Project Name: **Briggs Village North Multi-family**

Master File #: 16-9092

- Concept Design Review
- Detail Design Review
- Combined Design Review**

Date: May 11, 2017

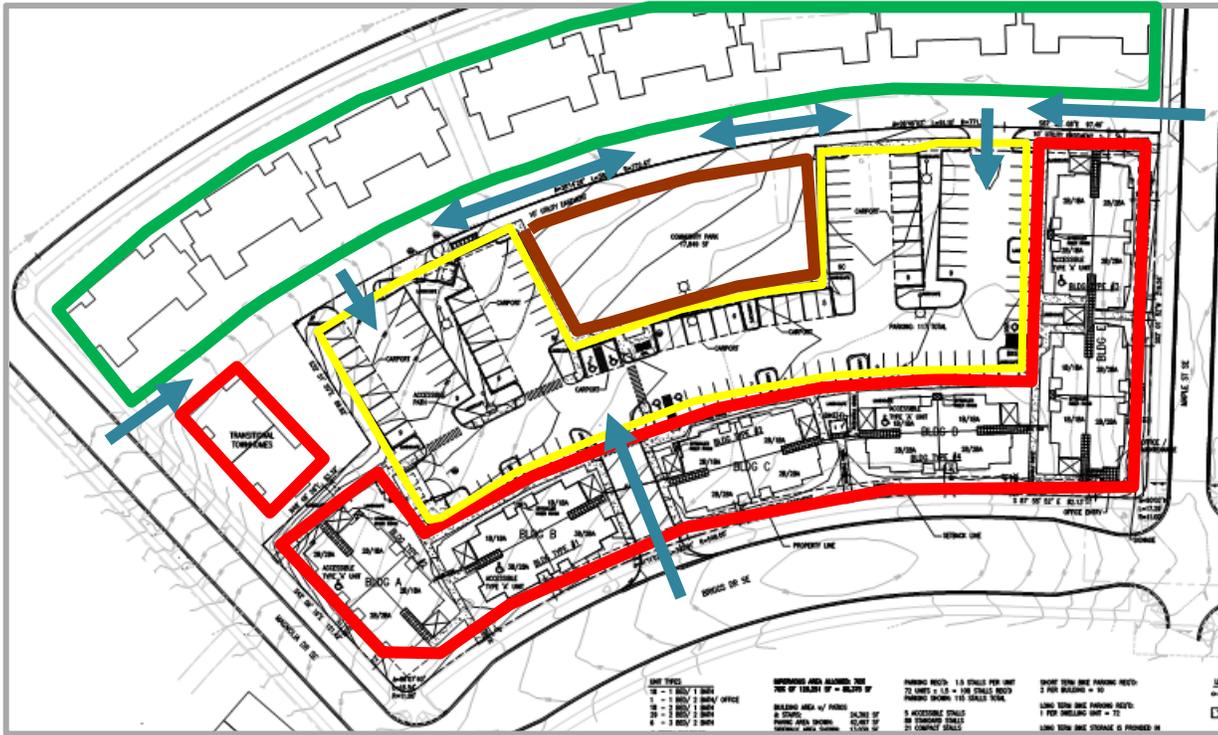
However, given that the 20 foot wide alley will be utilized for access to the project development for new cars, trucks, and pedestrians associated with 72 residential units, and the triplex and fourplex units north of the alley park their vehicles and place their solid waste and recycle containers along the alley for pickup – there will be much more activity in the alley and around the site.

Staff feels that the safety and comfort of site residents and surrounding property owners, as well as residents throughout the Briggs Village, should be a high priority. The North Commons Park, however visible from rights-of-way, is surrounded by roadways with the potential for safety issues. More is needed to alert both pedestrians and drivers to the increased alley activity, to slow traffic volume, and to reduce the potential for pedestrian and vehicle conflicts.

This site plan above depicts elements such as buildings surrounding the parking lot – RED, surface parking for the development - YELLOW, the community park - BROWN, and the triplex and fourplex units north of the alley - GREEN. The BLUE arrows indicate vehicular circulation on surrounding streets and through the alley.

1. Provide clearly distinguishable/marked pavement treatments – consult with City Transportation and Engineering to design and locate appropriate treatments.
2. Install signage to define the (intended) traffic calming areas – consult with City Engineering to design and locate appropriate signage.
3. Provide low-level fencing between the community park and the alley. The fencing shall not exceed 48 inches in height, and shall be designed to provide openings in the fence line for clear visibility and natural surveillance.
